**CALIFORNIA COASTAL COMMISSION**

**TU 13n****STAFF REPORT: REGULAR CALENDAR**

**APPLICATION NUMBER:** 5-01-409

**PROJECT DESCRIPTION:** Interior remodel and construction of a 591 square foot, 12.5-foot high first story addition at the rear of an existing 3,152 square foot, two-story single family residence on the bluff top, and construction of three retaining walls, a 404 square foot patio area with spa and stairs, and a 281 square foot wood deck located 12 inches above existing grade on the bluff top in the rear yard of a 27,780 square foot, R-1 zoned bluff lot. A total of 8.9 cubic yards of excavation and fill would be required to install the spa, and 34.8 cubic yards of excavation and fill would be required for the proposed patio, stairs and footings.

## SITE PLAN & ROOF PLAN

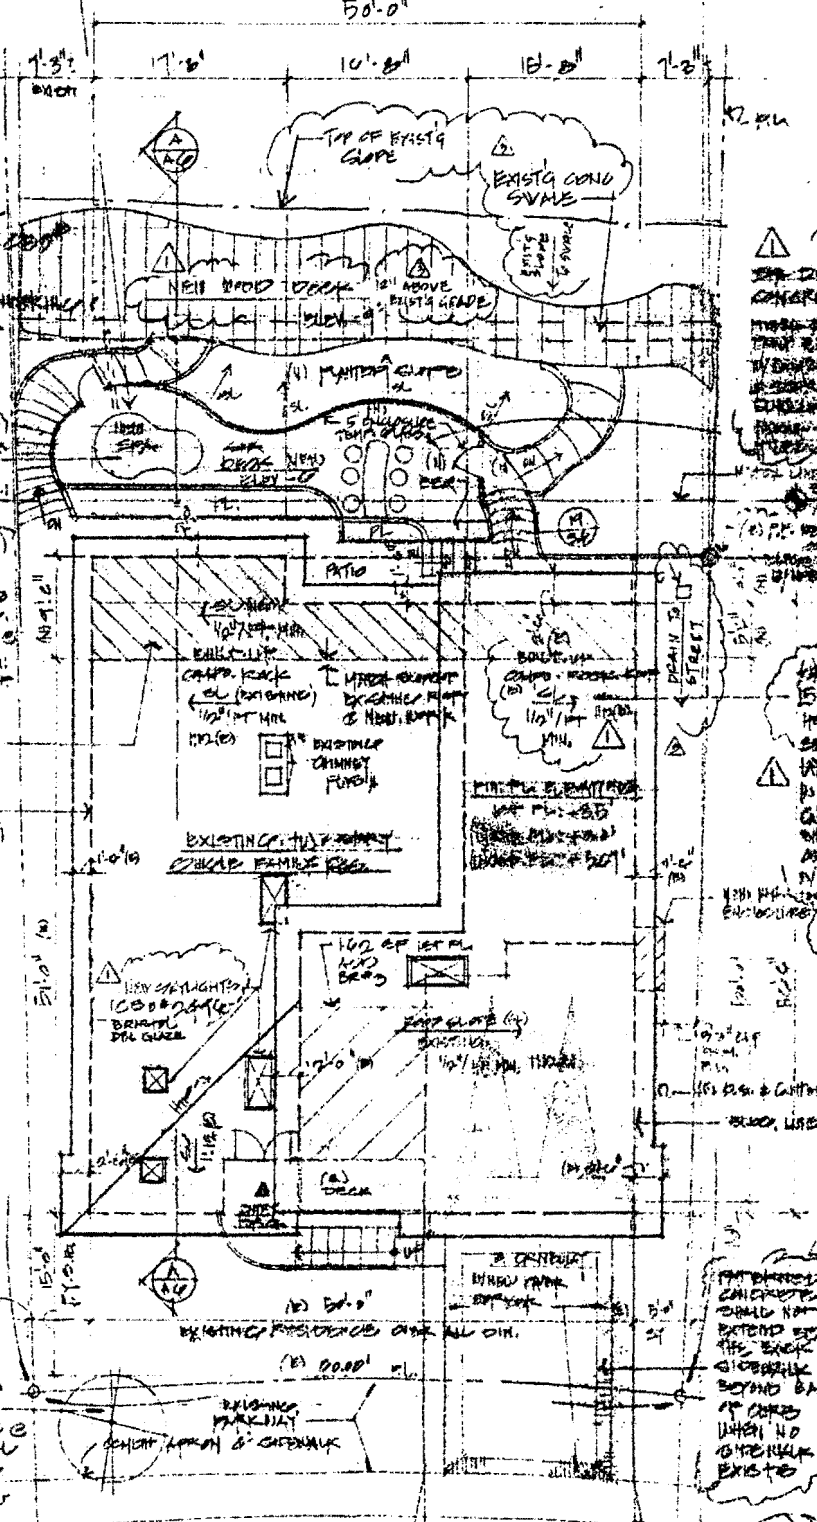
**DRAINAGE NOTES:**  
 PROVIDE SUB LEVEL DRAIN LINES AT BASE OF SPA W/ COLLECTOR PERIMETER PIPE DIRECTLY TO EXISTING CONC. SWALE. - ALL DRAINAGE FROM EXISTING HOUSE & PROPOSED ADDITION TO GO TO STREET.
